Alberta Transportation Springbank Off-stream Reservoir Project

Response to Part A IAAC Follow-up Questions

April 2021

Figure 1 Project Overview..... 5

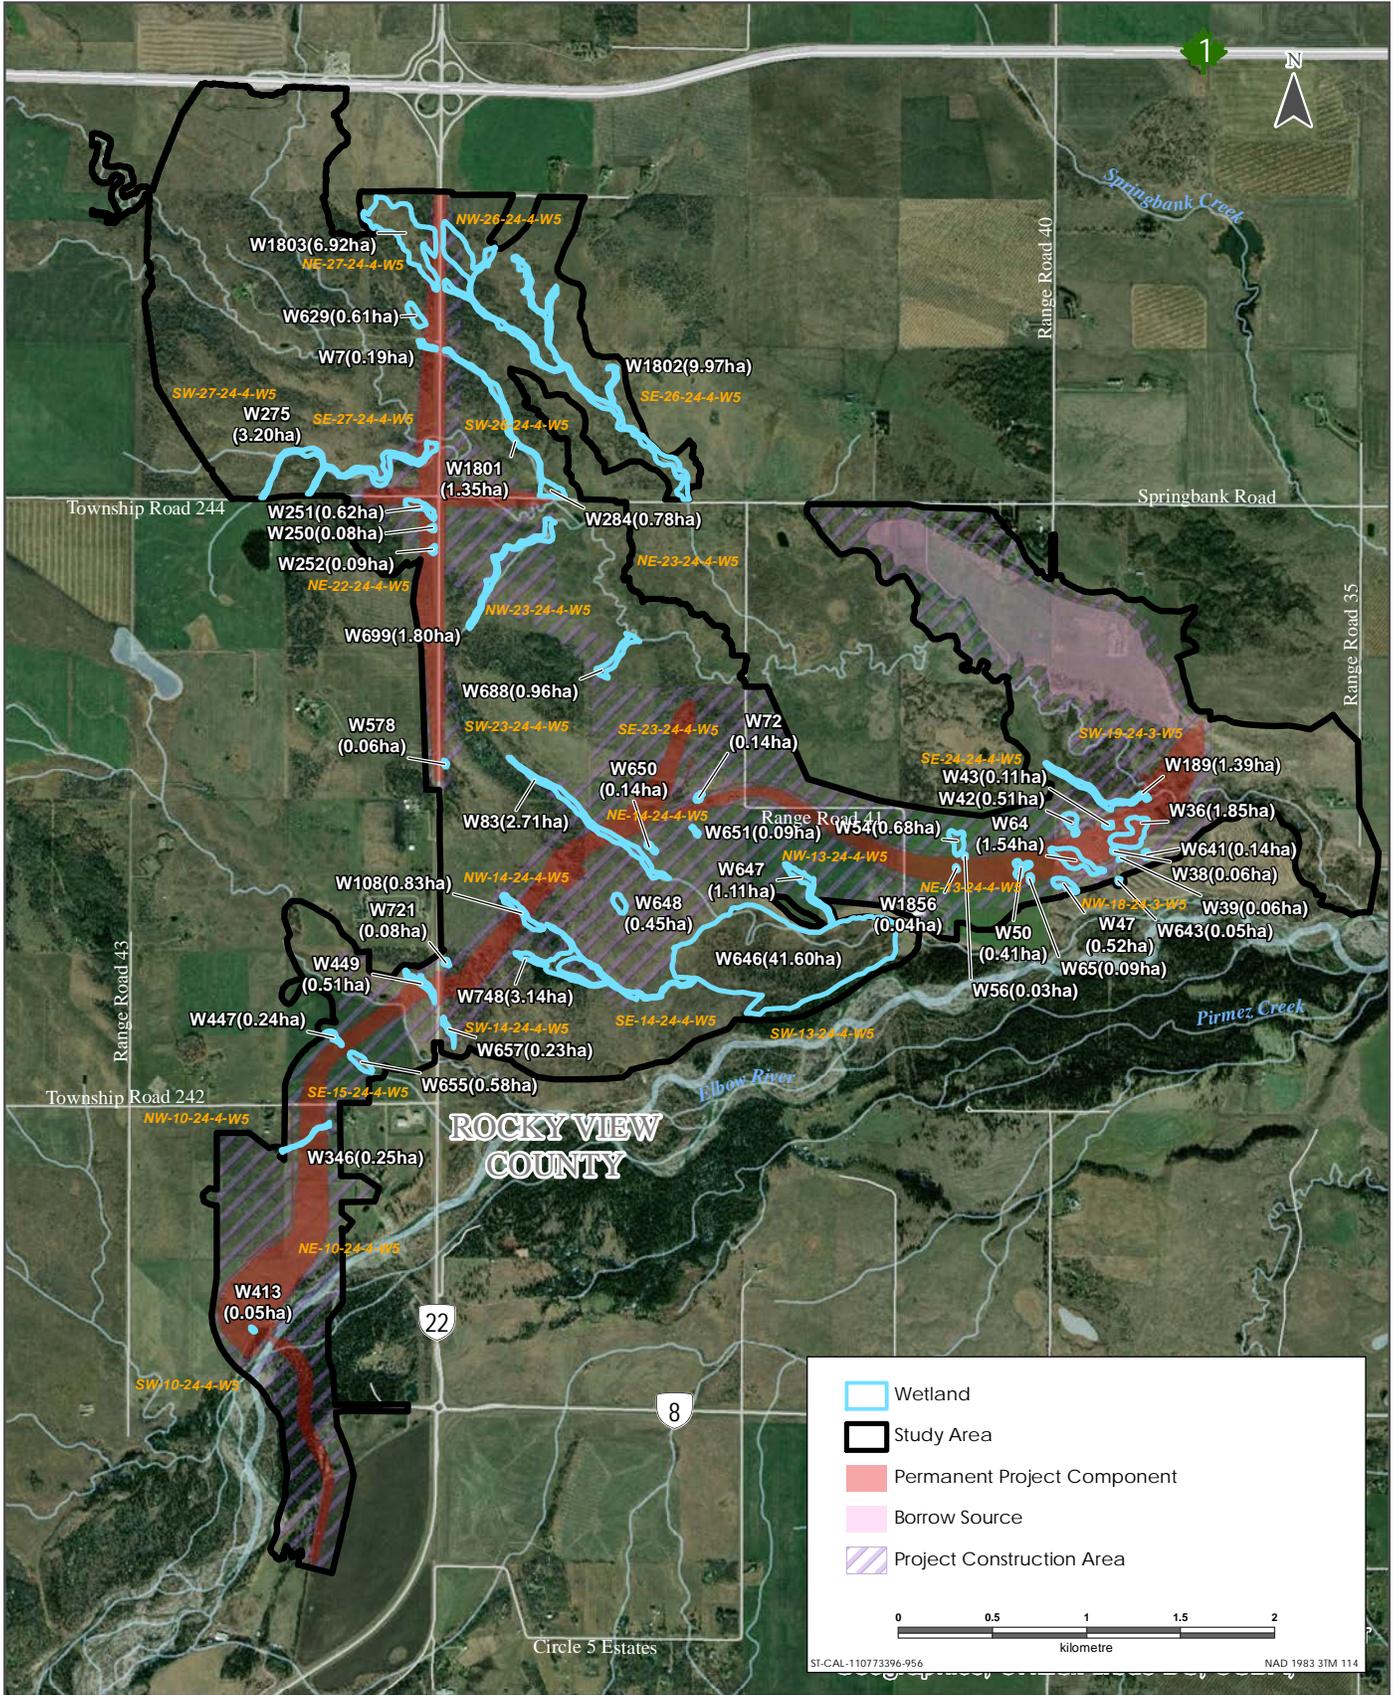
Request: We discussed the challenges of redirecting drainage channels away from the diversion channel, and that water that enters the diversion channel will go to the reservoir where there are wetlands. IAAC has requested if we can point them to a map of the wetlands in the reservoir.

Alberta Transportation has mapped existing wetlands across the wetted area of the Project, as shown in Figure 1 below. As illustrated, wetlands are present across much of the Project area, and therefore, the request to direct flow away from the existing wetlands is not practical at many locations. However, Alberta Transportation will direct flow away from wetlands during construction, if practical, through reducing disturbance of the project footprint, along with maintaining pre-construction drainage patterns where feasible using culverts, bridges and naturally occurring low points. Alberta Transportation will implement mitigation measures as provided in the draft vegetation and wetland mitigation, monitoring and re-vegetation plan, and use sediment and erosion control and other best management practices during the construction period.
